RFP # 7366

Acquisition and Development of Block 22

Questions and Answers

Attachment L - Freeway Footing/Pier Locations

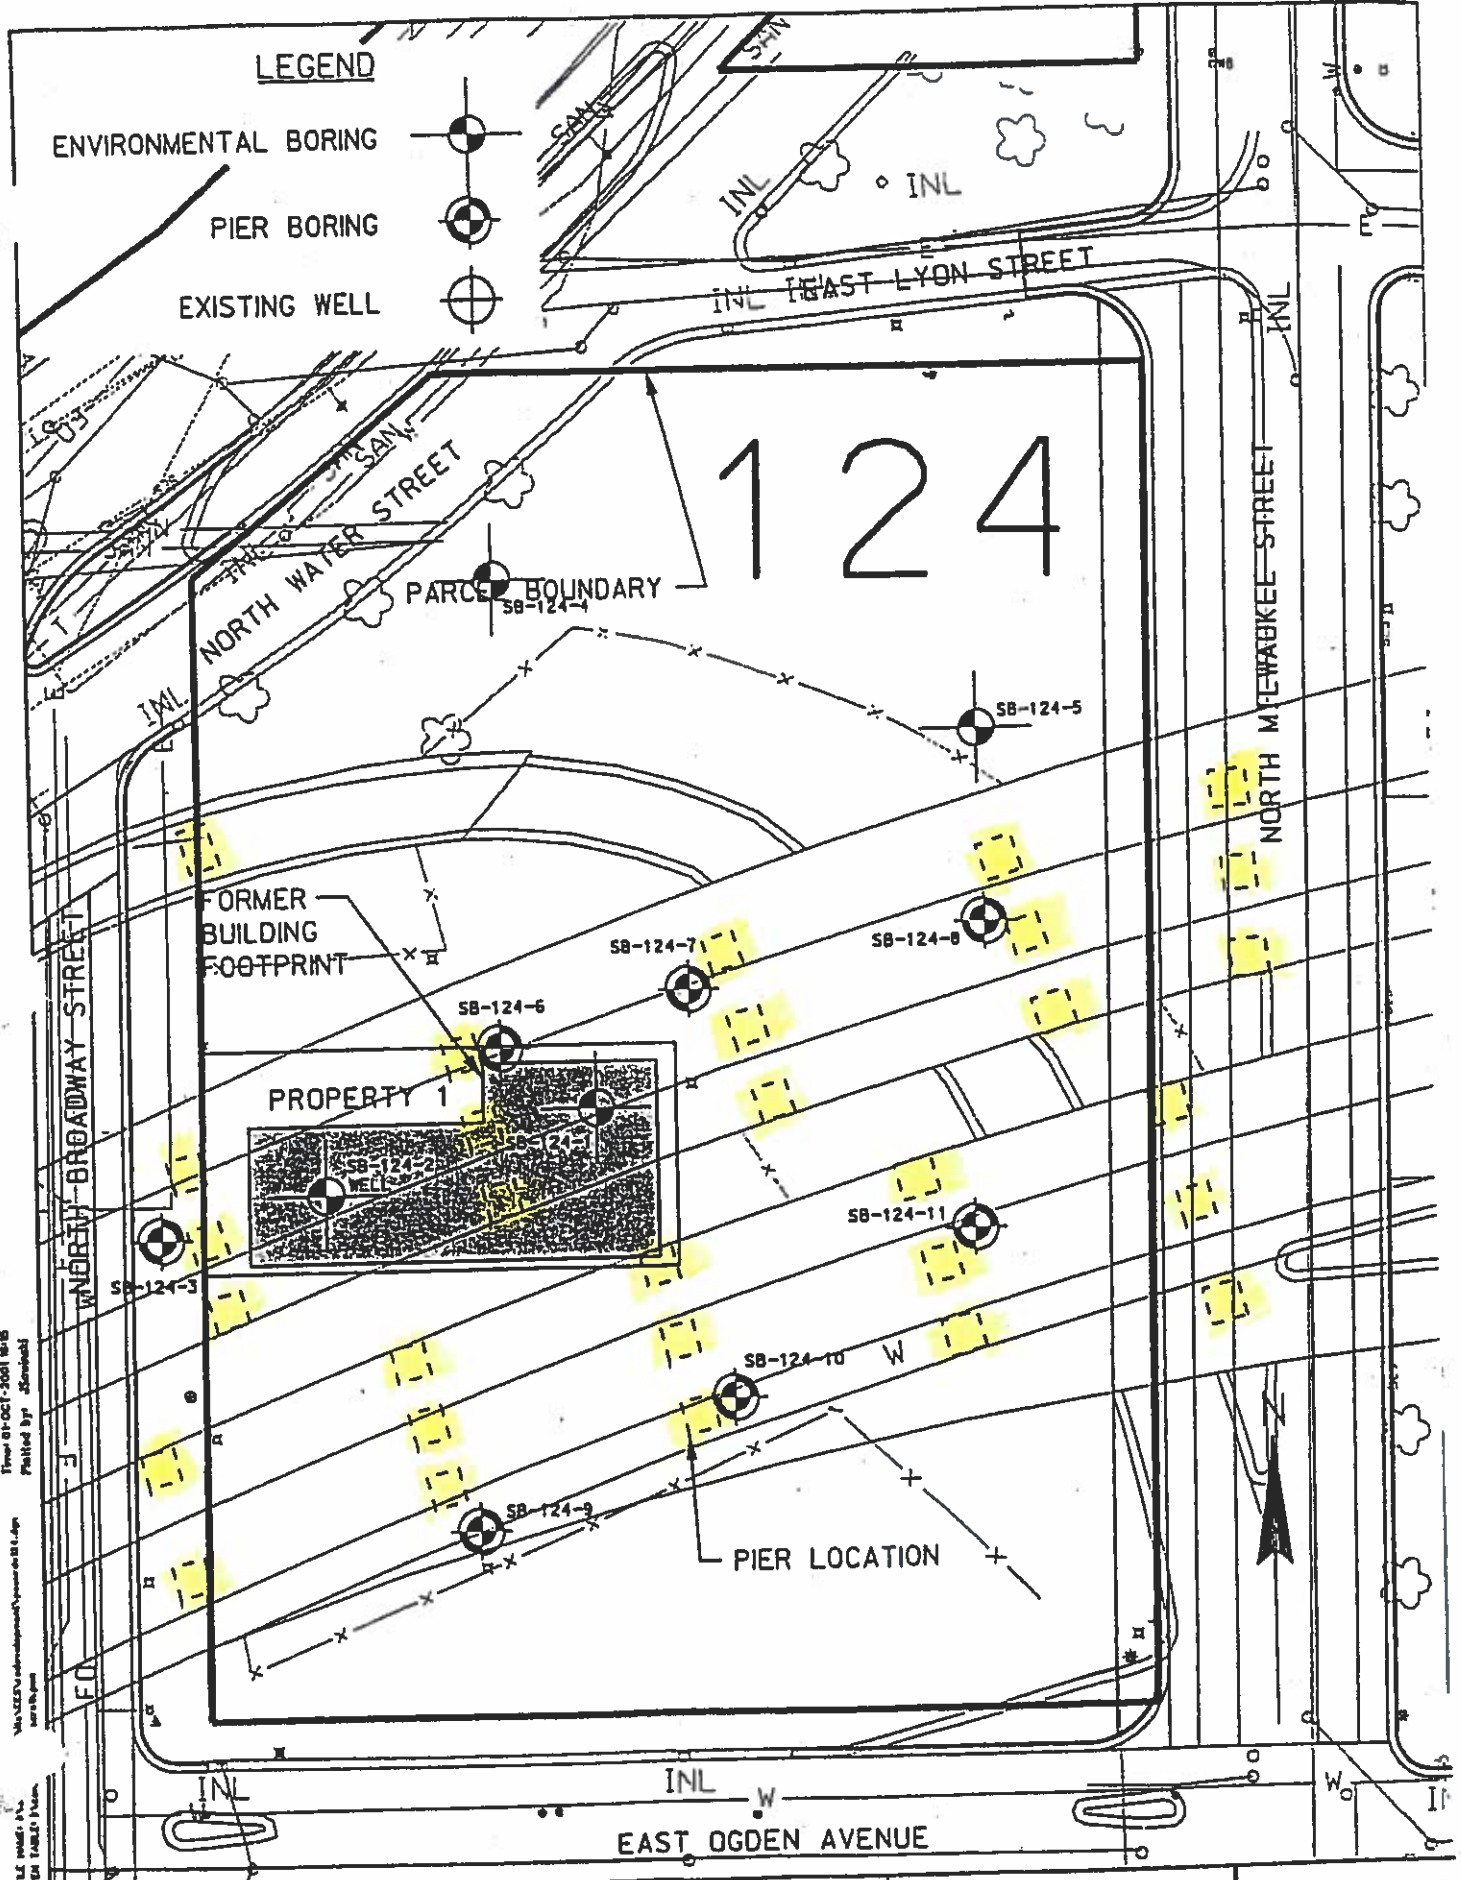
1. Section 2.6 Subsoil Conditions (page 7), in the first paragraph it references Attachment L as a map showing the general locations of the remaining footings. The map which was attached to the RFP was for Blocks 2 & 4. Is there a map of these remaining footings for the subject site Block 22?

Attached is Attachment L the footings for Block 22.
